RAI Volume 2, Chapter 2.1.1.4, Fifth Set, Number 7:

Explain how DOE developed the nuclear safety design basis for the cask cooling subsystem identified in Table 6.9-1 of BSC, 2008bq on page 234. Examples of areas needing clarification follow:

Figure 1. Revised Model of Overpressurization of the Cask Cooling System

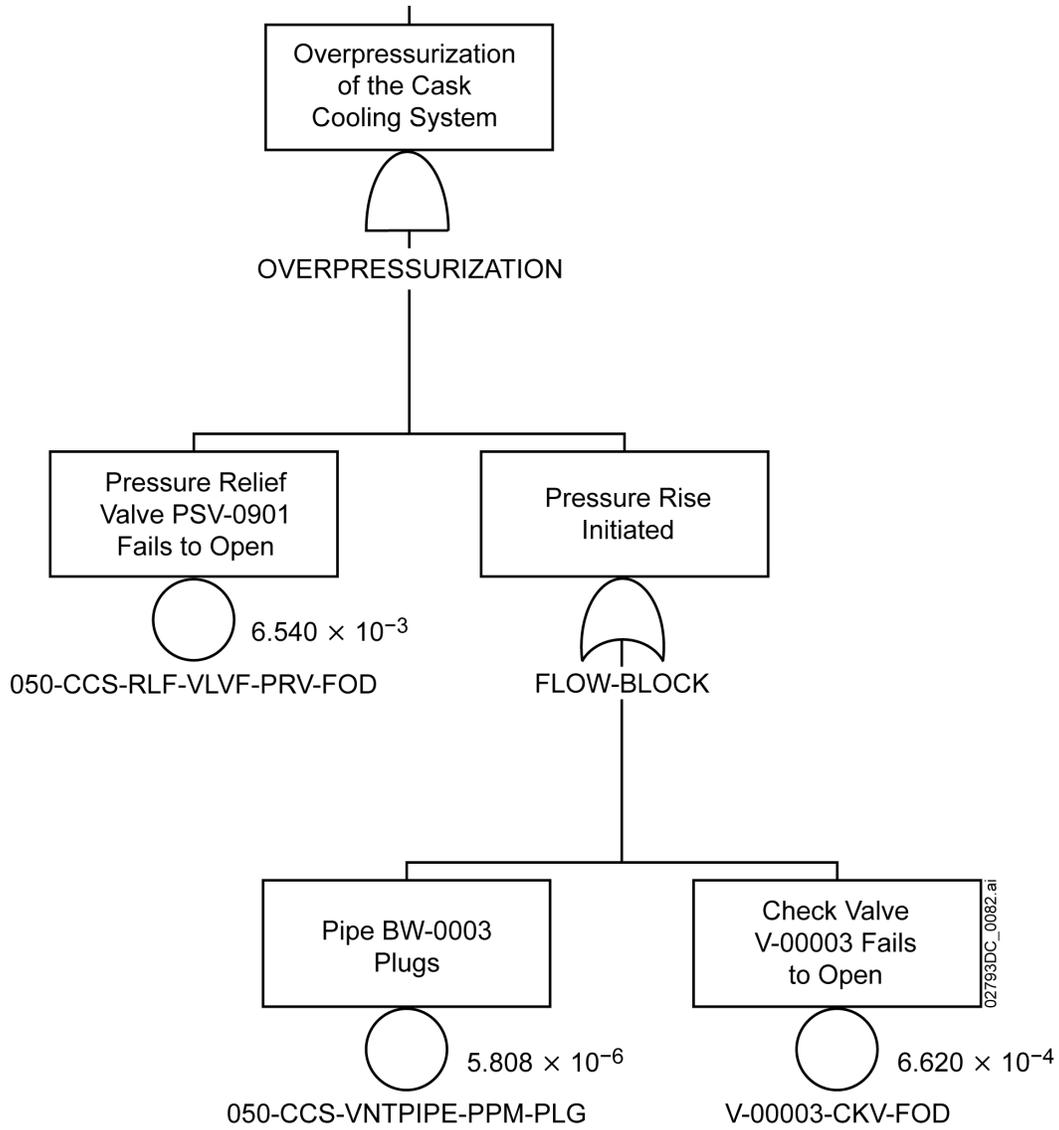
- (a) Explain if the operator error, “Operator causes overpressurization” identified as basic event 050-OPDPC-OVP01-HFI-NOW shown in Figure B5.4-8 of BSC, 2008bq is included as part of the nuclear safety design basis. The operator error is connected by an “OR” gate to the components that are part of this system.

- (b) Explain if all components that could result in an over pressurization have been accounted for in Figures B5.4-8 and B5.4-9. For example, DOE identifies failures such as pump failure and relief valve failure. DOE shows in Figure 1.2.5-69 of the SAR, the piping and instrument diagram for the Cask Cooling Subsystem. This figure also shows check valves and pressure transmitters. Explain if these other components can contribute to an over pressurization.

- (c) DOE identifies, “Pipe BW-0003 plugs” in Figure B5.4-9 of BSC, 2008bq. Clarify where this pipe is and explain if this failure accounts for all of the areas where a pipe could plug and result in an over pressurization.

The cask cooling subsystem overpressurization event has been reevaluated since issuance of *Wet Handling Facility Reliability and Event Sequence Categorization Analysis* (BSC 2009), and the system fault tree model for overpressurization of the cask, canister, or sample line due to failures of the cask cooling subsystem has been revised. The revised system fault tree model is provided in Figure 1. The new model and accompanying text assess the relationship among the various components in the subsystem and their contributions to an overpressurization event. Overpressurization failure of the cask, canister, or sample line is modeled to occur only if both the pressure relief valve and the vent line to the gas/liquid separator fail to control the pressure.

In the fault tree model of the cask cooling subsystem (BSC 2009, Section B5.4.2), overpressurization was modeled as being caused by excess cooling water introduced into a heated cask or canister. Excess cooling water cannot overpressurize the system. As a result, the fault tree model of Figure 1 more accurately represents the cask/canister cooling subsystem design. The revised fault tree reflects the fact that both the vent line (shown as the vent line between the cask/canister and the gas/liquid separator vessel in SAR Figures 1.2.5-69 to 1.2.5-72) must fail to adequately pass fluid and the pressure relief valve (shown on the line from the cask/canister to the Wet Handling Facility pool in SAR Figures 1.2.5-69 to 1.2.5-72) must fail closed for the initiating event to occur. The manual valve on the vent lines will be locked open during operation; as a result, the probability of this valve failing to remain open will be dominated by random mechanical failure, which is an order of magnitude or two lower than the check valve failure probability. Operator error that results in inadvertent valve closure was not modeled for locked open manual valves.

Solving the Figure 1 fault tree results in a top event probability of 4×10^{-6} . This probability is less than the value stated as a nuclear safety design basis for the cask cooling subsystem, 8×10^{-6} (SAR Table 1.9-4). Therefore, the categorizations of cask overpressurization event sequences are not changed using this revised fault tree model.

The following components on the inlet side of the cask or canister have been modeled in the categorization analysis document (BSC 2009): the cooling water feed pump, the digital control system (through a spurious signal demanding excessive flow from the pump), and the pressure relief valve. The model in Figure 1 does not include the spurious signal from the digital control system because, as noted in Section 1, overpressurization cannot be caused by excessive flow from the cooling water feed pump.

thereby allow pressure to build up within the cask or canister. The revised model includes the check valve. Because the manual ball and butterfly valves are in the vent line, normal operating procedures would ensure that they are locked open during operation.

Because the probability that the normally locked open valves would be inadvertently left closed (conservatively, 1×10^{-5}), and the probability that manual valves (BSC 2009, Attachment H SAPHIRE model basic event DMP-FRO [8.4×10^{-8}]) would fail closed are lower than check valve failure probabilities (BSC 2009, Attachment H SAPHIRE model basic events CKV-FOD [6.6×10^{-4}] and CKV-FTX [2.2×10^{-3}]), they are not modeled in Figure 1.
